CHICAGO PLAN COMMISSION

Former Field's Warehouse – PD Amendment (PD 1261)
4000 W. Diversey (31st Ward – Ald. Cardona)
KV 4000 Diversey Commercial LLC

PROJECT REVIEW COMMITTEE COMMENTS

Project Description: Knickpoint (PD1261)
 Location: 4800 W. Diversey
 Review Date: 11/24/2020

Southwest View_Current Design

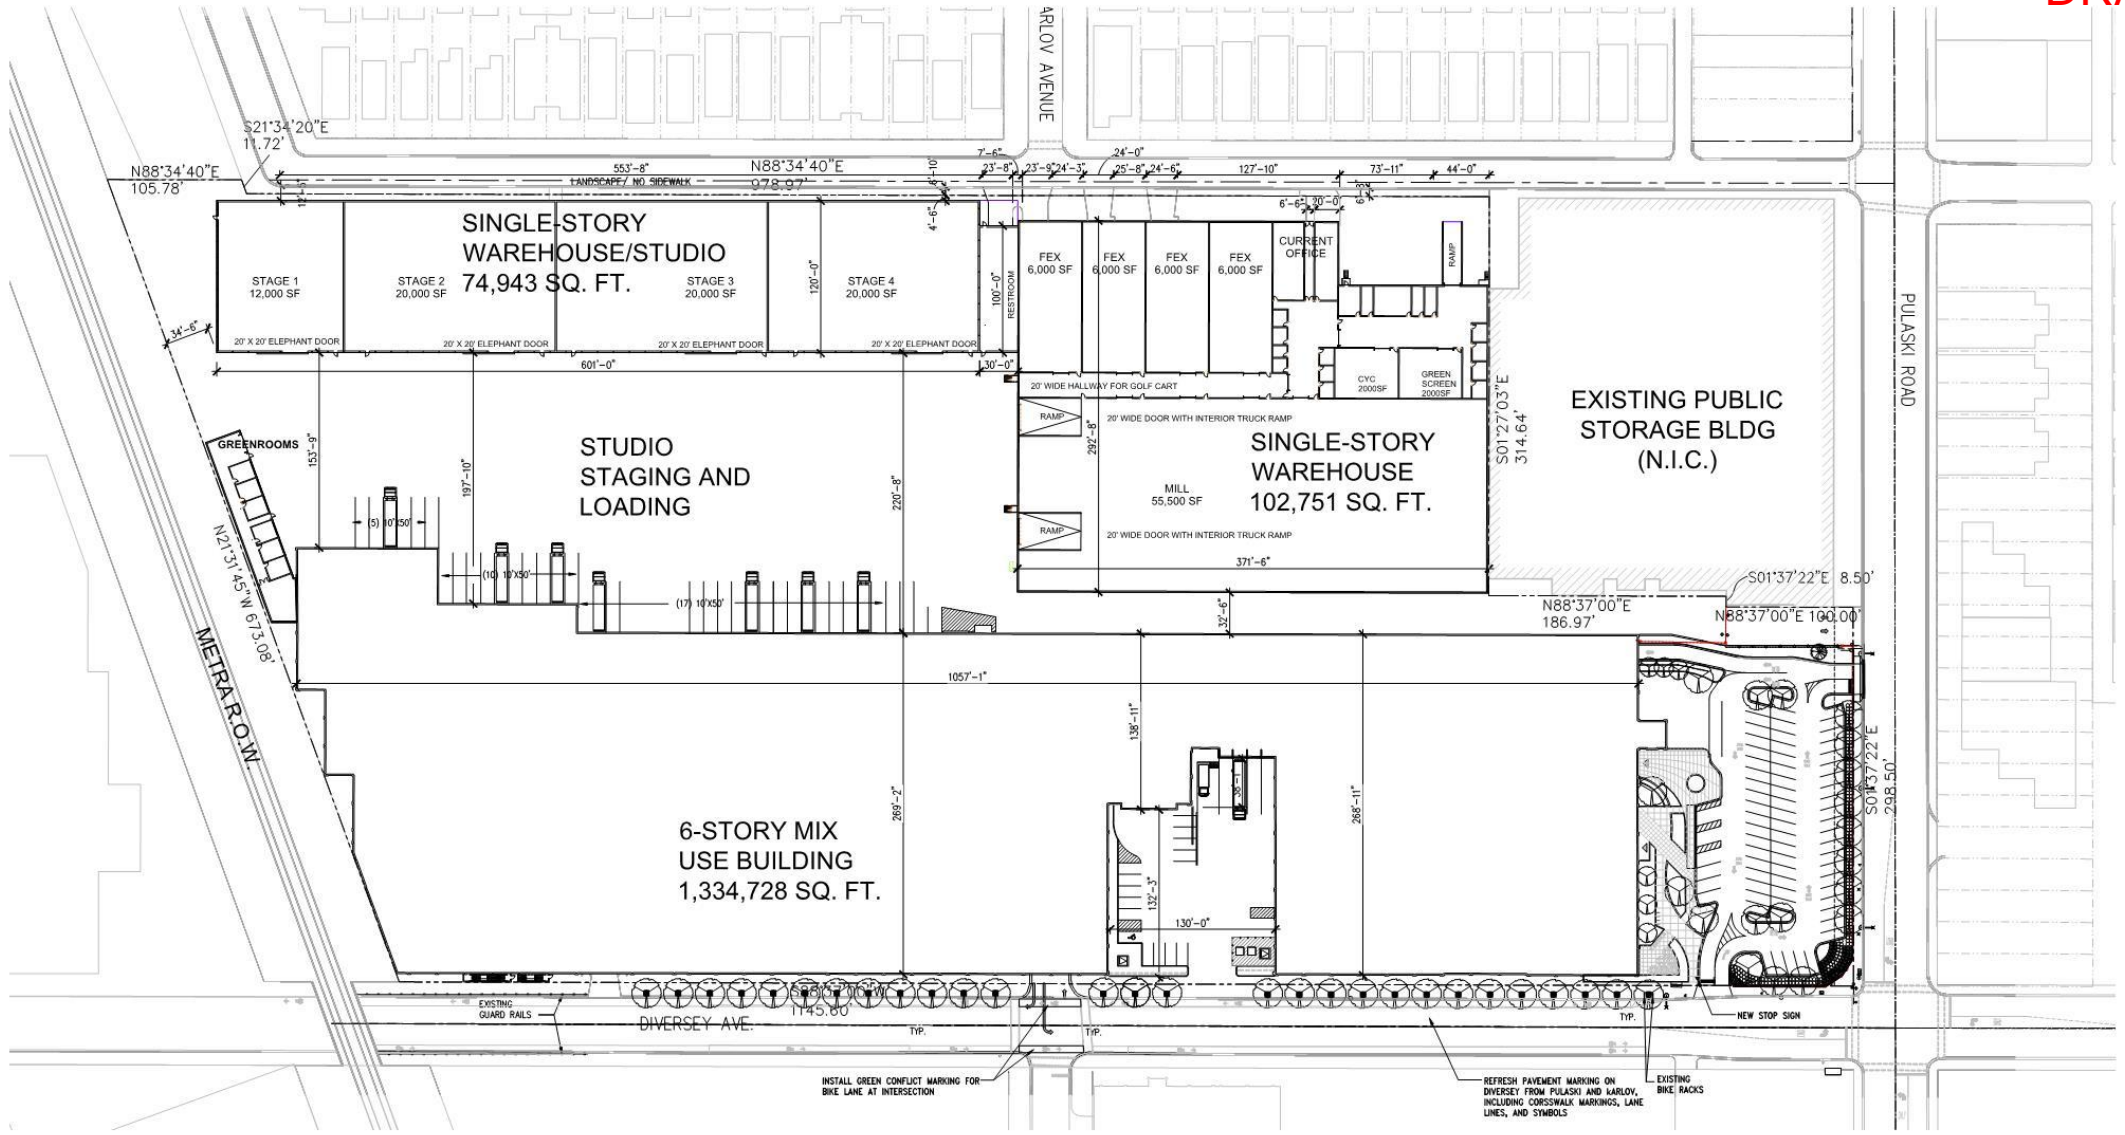
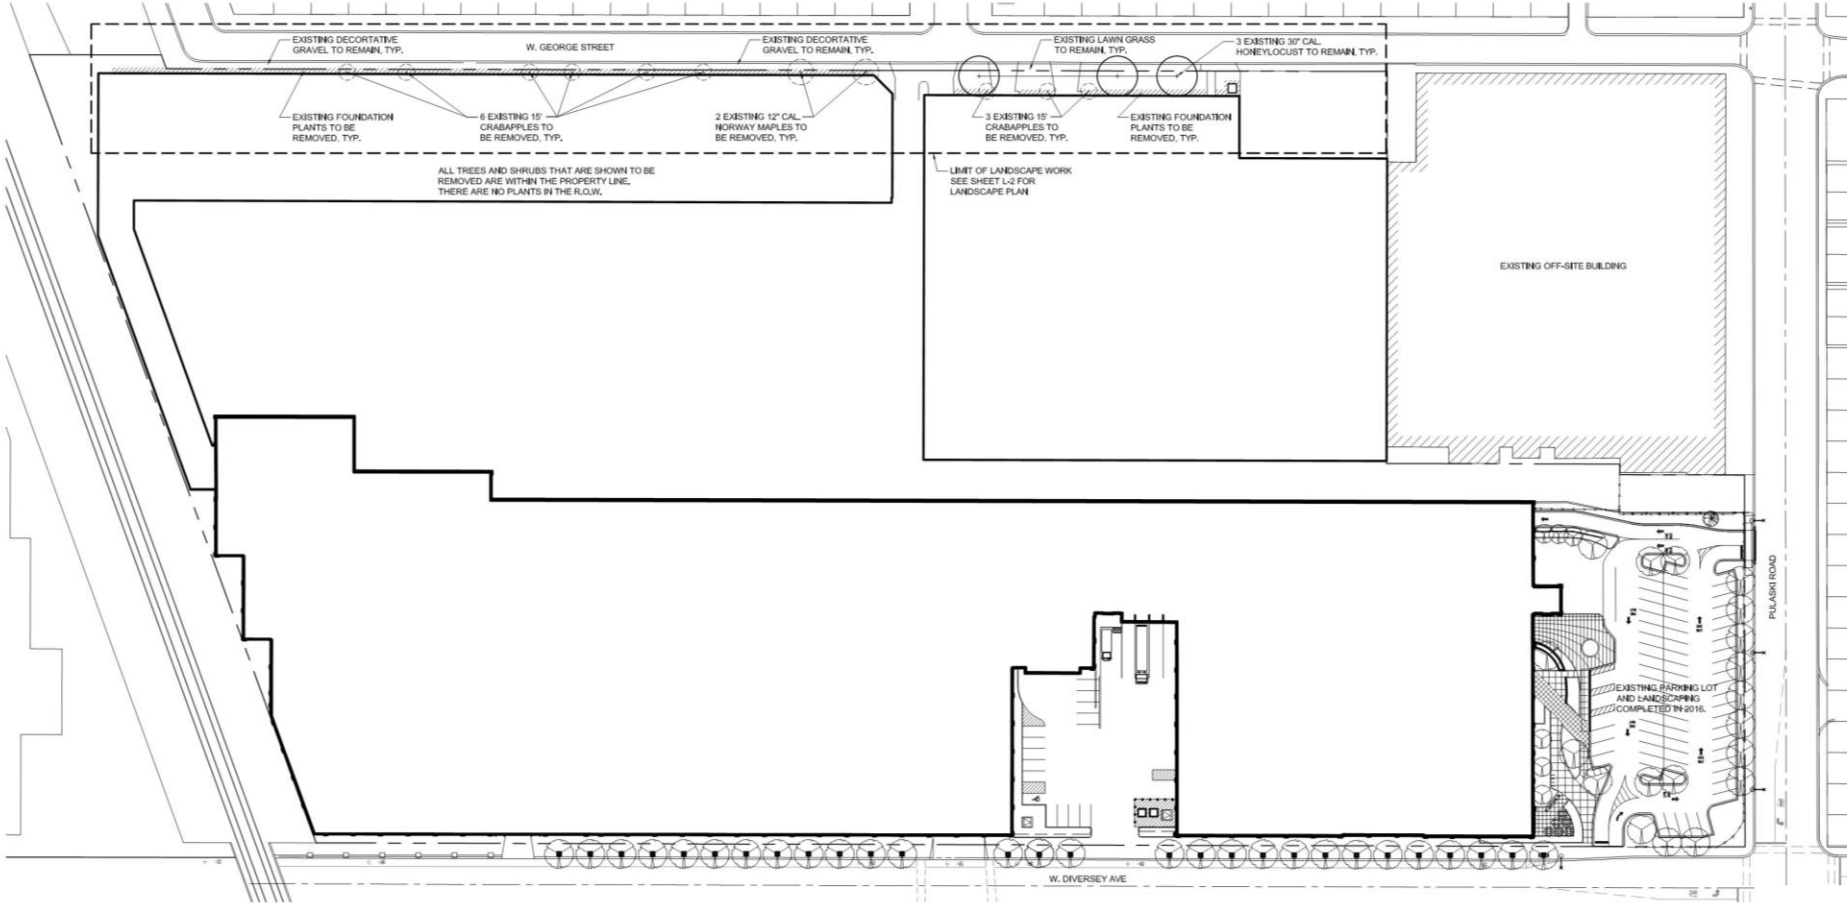
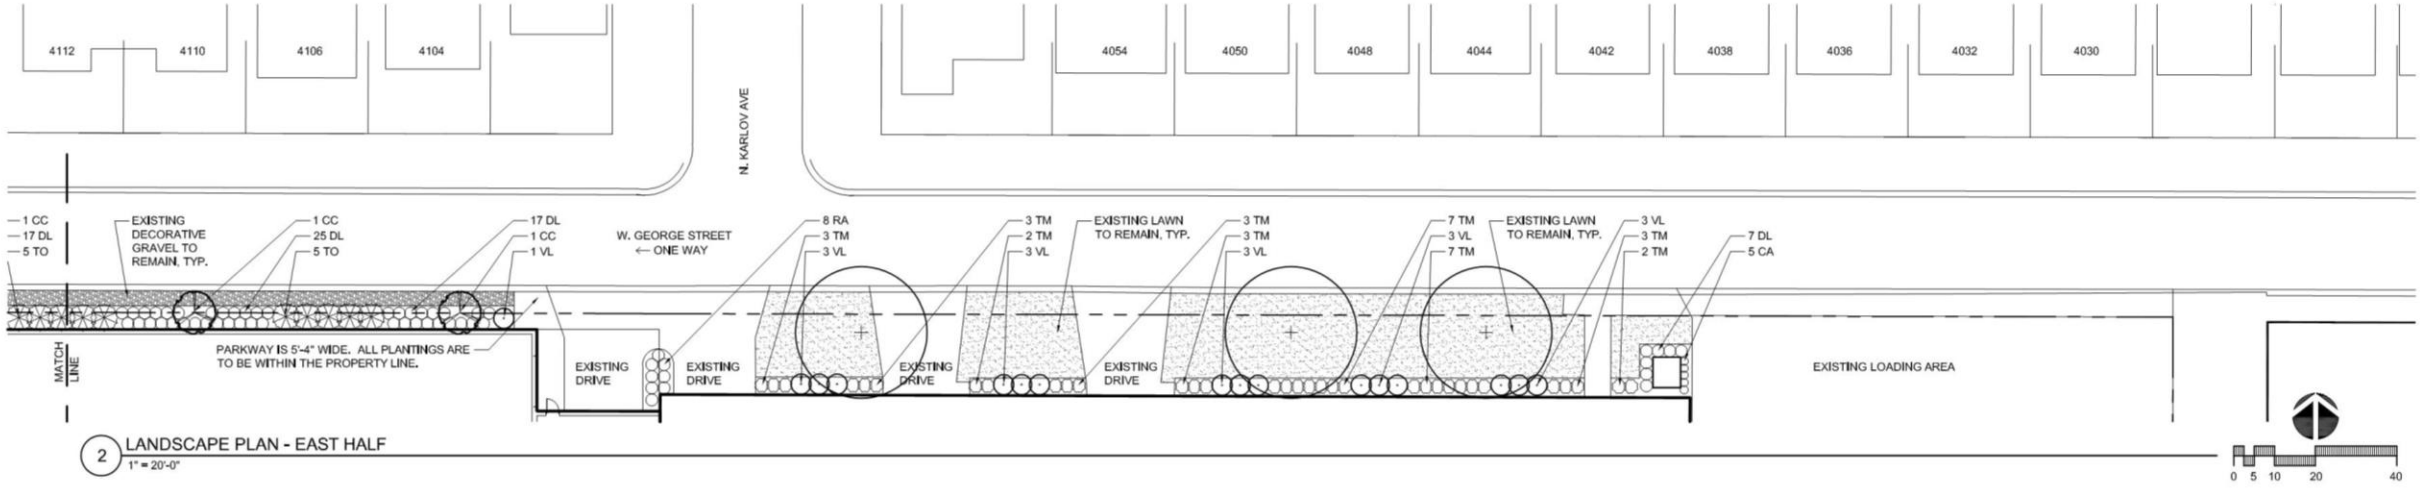
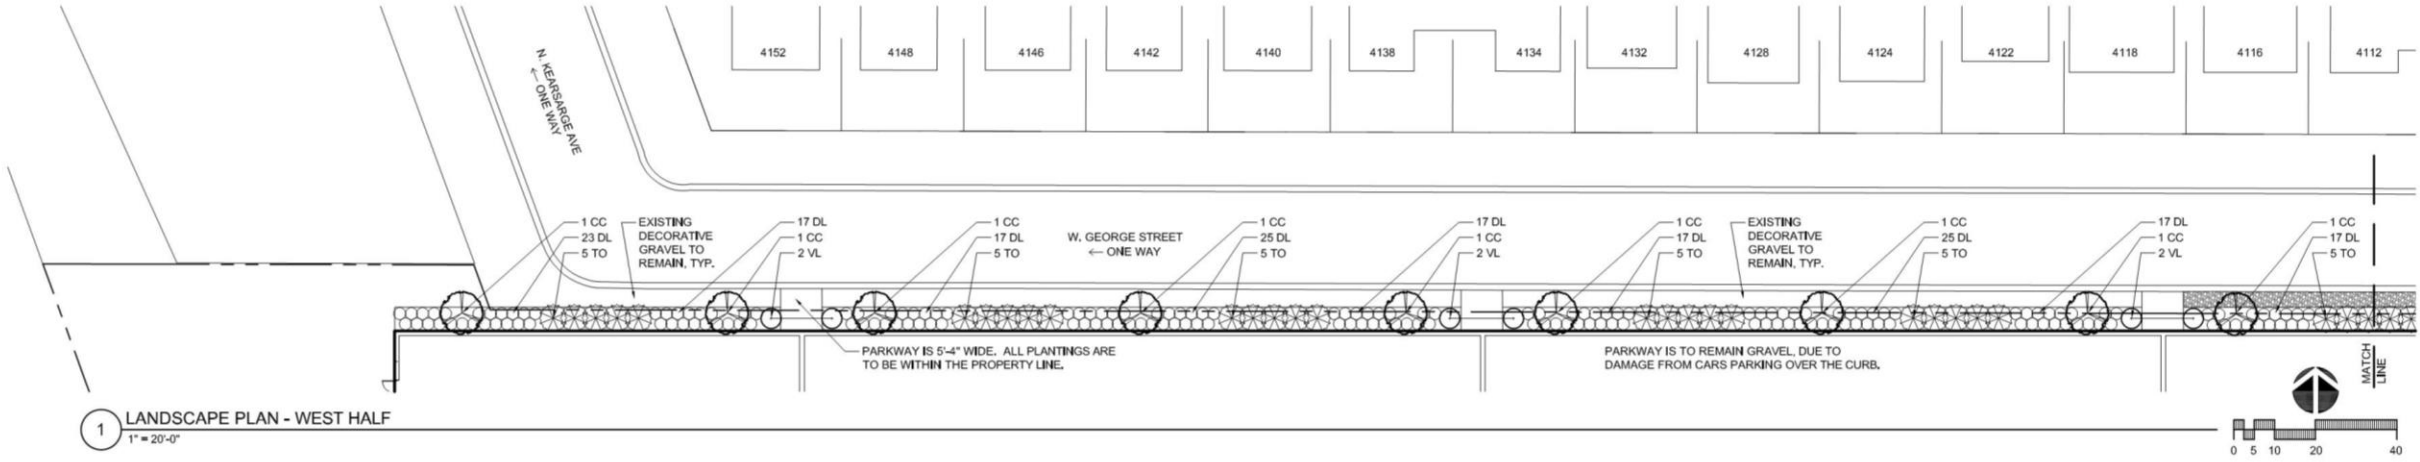
- New building elevations for the structures along George Street to allow for additional height needed for the proposed users of those buildings
 - Per community feedback, the proposed exterior height has been reduced from 50' to 44'

Traffic/Site plan comments

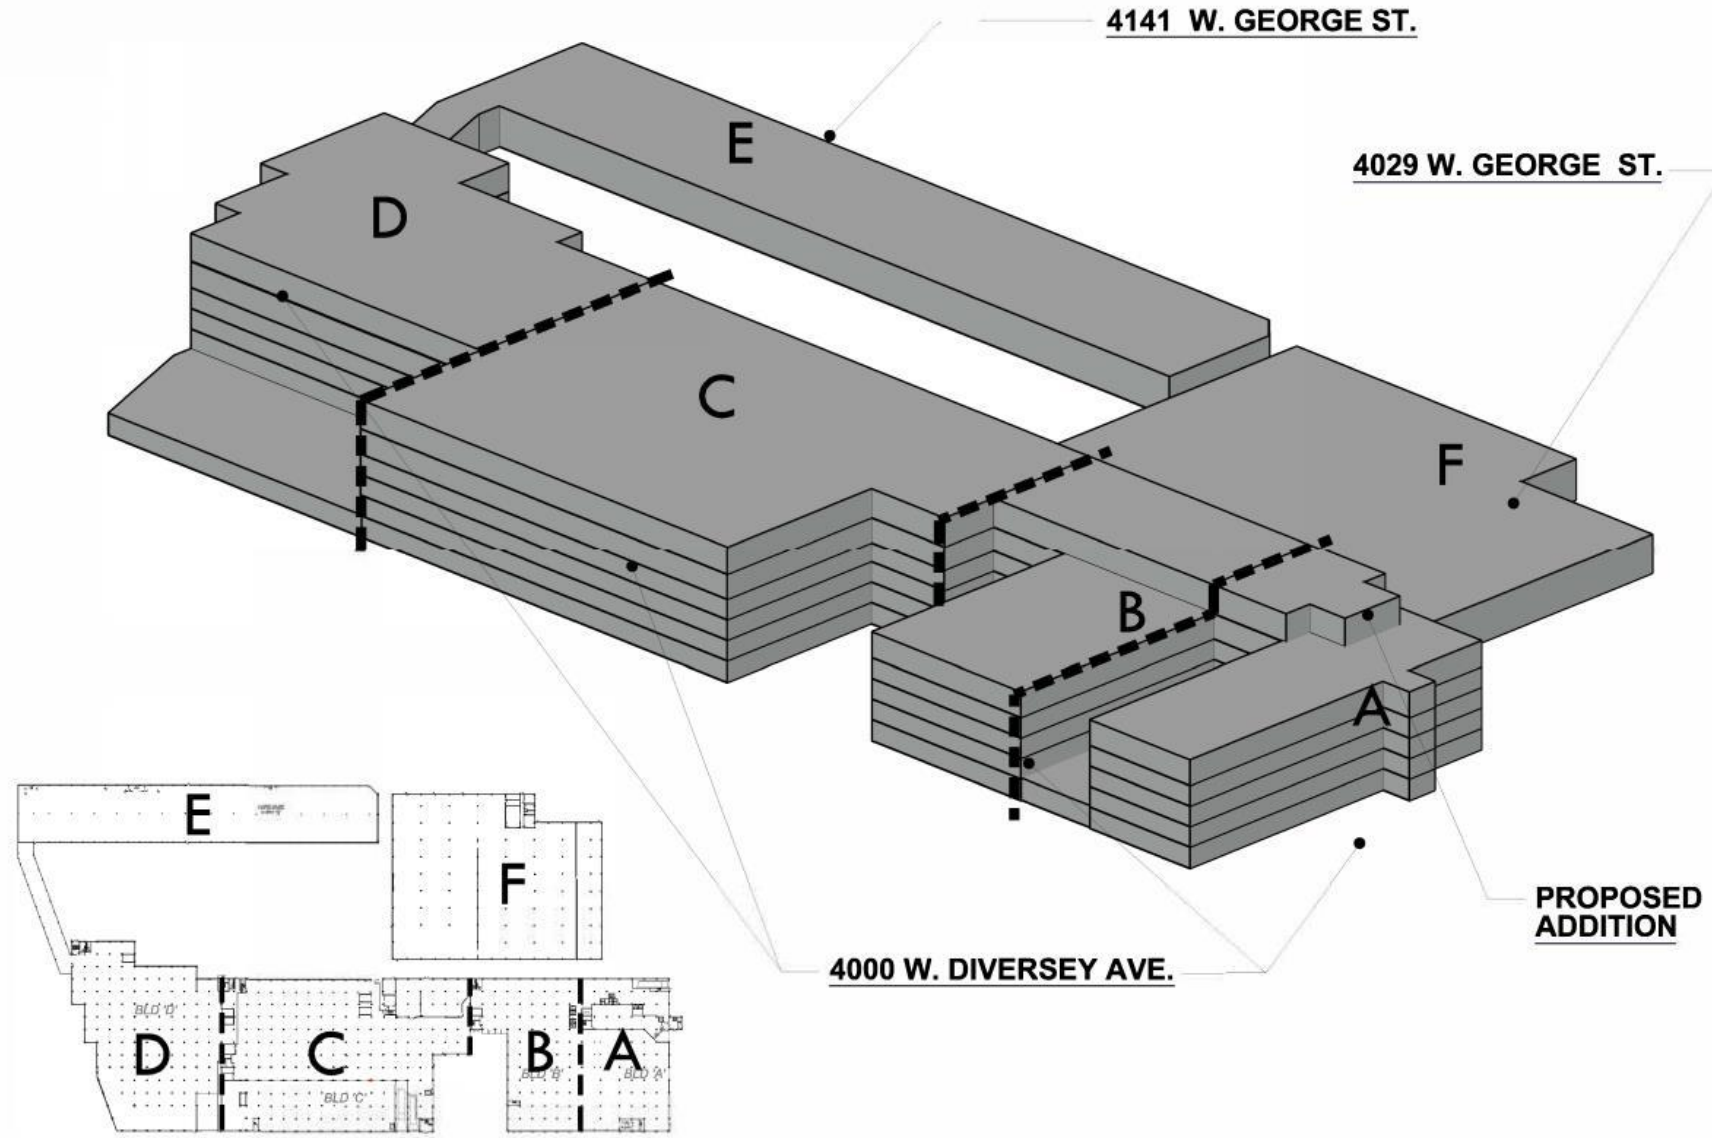
1. Install a stop sign at driveway access on Diversey facing outbound traffic, within private property.
2. Refresh pavement markings on Diversey from Pulaski and Karlov, including crosswalk markings, lane lines, and symbols. Show on site plan with note to restripe.
3. To highlight the bike lane on Diversey at Karlov, install green conflict markings. Show on site plan.
4. Install bike corrals/racks on sidewalk.
